Project Title: Niblick Road Complete and Sustainable Bike and Pedestrian Enhancement Project

Submitted by: Almond Acres Charter Academy Date: January 6, 2025

Drawing

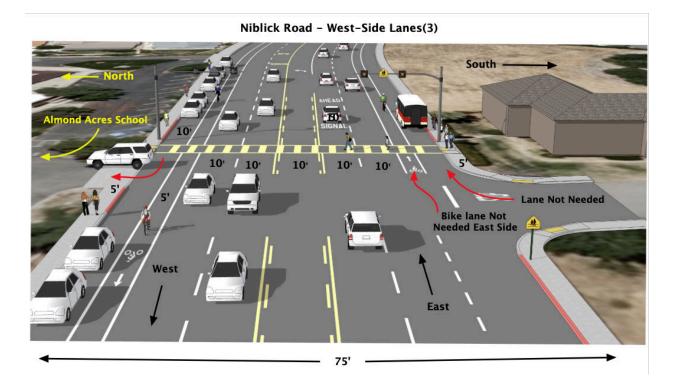
After thoroughly reviewing the W-Trans Niblick Road Complete and Sustainable Streets Corridor Plan (dated November 2, 2024), we propose a specific modification that aligns with the corridor's overall objectives while addressing our immediate safety concerns. Our primary request is to establish a dedicated right-turn lane on the westbound side of Niblick Road, extending from our east entrance driveway to Creston Road. This narrative outlines the "how" and "why" of this request.

Almond Acres Charter Academy requests the creation of three westbound lanes from Creston Road to the school during the resurfacing and re-striping of the Niblick Corridor Project.

The drawing below represents the request to create a dedicated right-hand turn lane at the east entrance to the school onto Creston Road while maintaining the bike lane.

Vehicle circulation is outside of the scope of this Project, as the grant is specific to alternative transportation. The Project includes improvements to the Corridor that are meant to improve safety, access, and mobility for all modes of transportation, specifically walking and bicycling. The Project does not change the number of travel lanes on Niblick Road, or lane geometry and traffic control at the intersections and driveways along the Corridor. There are existing locations along the Corridor where vehicles queue illegally within the bike lanes to access driveways. This creates an existing hazard for cyclists travelling within the corridor. The Project would alleviate this hazard by creating a path for multimodal travel and providing separation for pedestrians and cyclists from the vehicular travel lanes.

Almond Acres Charter Academy	F	F3	After thoroughly reviewing the W-Trans Niblick Road Complete and Sustainable Streets Corridor Plan (dated November 2, 2024), we propose a specific modification that aligns with the corridor's overall objectives while addressing our immediate safety concerns. Our primary request is to establish a dedicated right-turn lane on the westbound side of Niblick Road, extending from our east entrance driveway to Creston Road. This narrative outlines the "how" and "why" of this request. Technical Specifications • Be-striping following road surfacing • Adjustment of all traffic lanes to 10 feet in width • New turn lane measuring 10 feet in width (minimum required for a vehicle lane) • Eane width reduction to naturally decrease traffic speeds in school zone • Adequate queuing space for vehicles during peak periods The upcoming \$14 million grant for resurfacing, realigning, and re-striping Niblick Road from the bridge to Creston Road provides an excellent opportunity to implement these essential safety improvements. This timing would allow for the cost-effective integration of our proposed modifications into the planned construction work. This project offers a chance to address the safety concerns outlined in this proposal. As described in this proposal, the academy has requested that officials investigate, develop, and implement	Vehicle circulation is outside of the scope of this Project, as the grant is specific to alternative transportation. The Project includes improvements to the Corridor that are meant to improve safety, access, and mobility for all modes of transportation, specifically walking and bicycling. The Project does not change the number of travel lanes on Niblick Road, or lane geometry and traffic control at the intersections and driveways along the Corridor. There are existing locations along the Corridor where vehicles queue illegally within the bike lanes to access driveways. This creates an existing hazard for cyclists travelling within the corridor. The Project would alleviate this hazard by creating a path for multimodal travel and providing separation for pedestrians and cyclists from the vehicular travel lanes.
